Subject: St. Rene Road Pump Station In-Line Storage  
Minor Project Modification  
IOAP Project No. S\_FF\_CH\_NB01\_S\_09A\_C\_A  
DOJ Case No. 90-5-1-1-08254

MSD is requesting approval of a proposed minor project modification to the St. Rene Road Pump Station In-Line Storage project (IOAP Project No. S\_FF\_CH\_NB01\_S\_09A\_C\_A). This modification is part of an overall adaptive management review of the approved 2012 IOAP Modification, and in response to an opportunity that presented itself as a result of conditions not foreseen during development of the IOAP.

**Integrated Overflow Abatement Plan**  
**Vol. 3 - Sanitary Sewer Discharge Plan**  
**Chenoweth Hills Sewershed**  
**St. Rene Rd. PS Inline Storage**

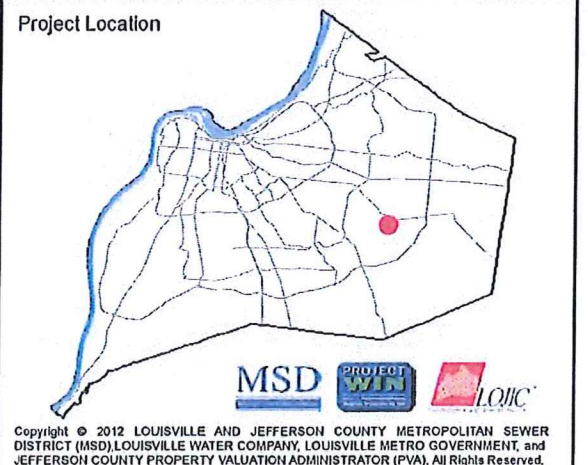
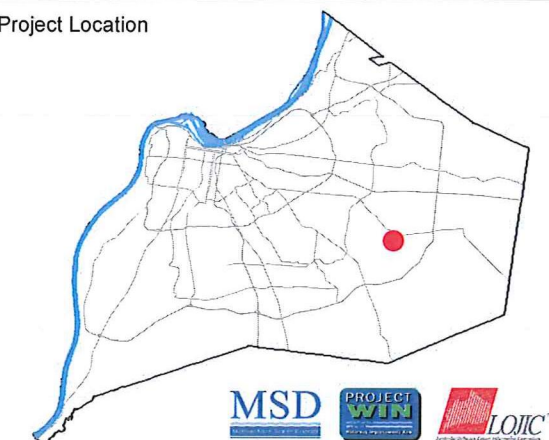
The St. Rene Road Pump Station In-Line Storage project originally involved replacing 42 LF of 8-inch diameter gravity sewer with 48-inch diameter pipe to provide in-line storage. This in-line storage was intended to attenuate flow peaks that exceeded the capacity of the St Rene Road Pump Station, thereby eliminating the SSO at the pump station. This project has an IOAP completion date of December 31, 2021.

The project modification proposed eliminates the St. Rene Road Pump Station by constructing approximately 700 LF of 15-inch diameter gravity sewer to the Upper Billtown Interceptor, which was constructed as part of the Jeffersontown Water Quality Treatment Center (WQTC) final elimination plan.

**Project Description** This alternative includes elimination of the pump station with a new 15" diameter sewer. Flow will be diverted to the Cedar Creek WQTC..
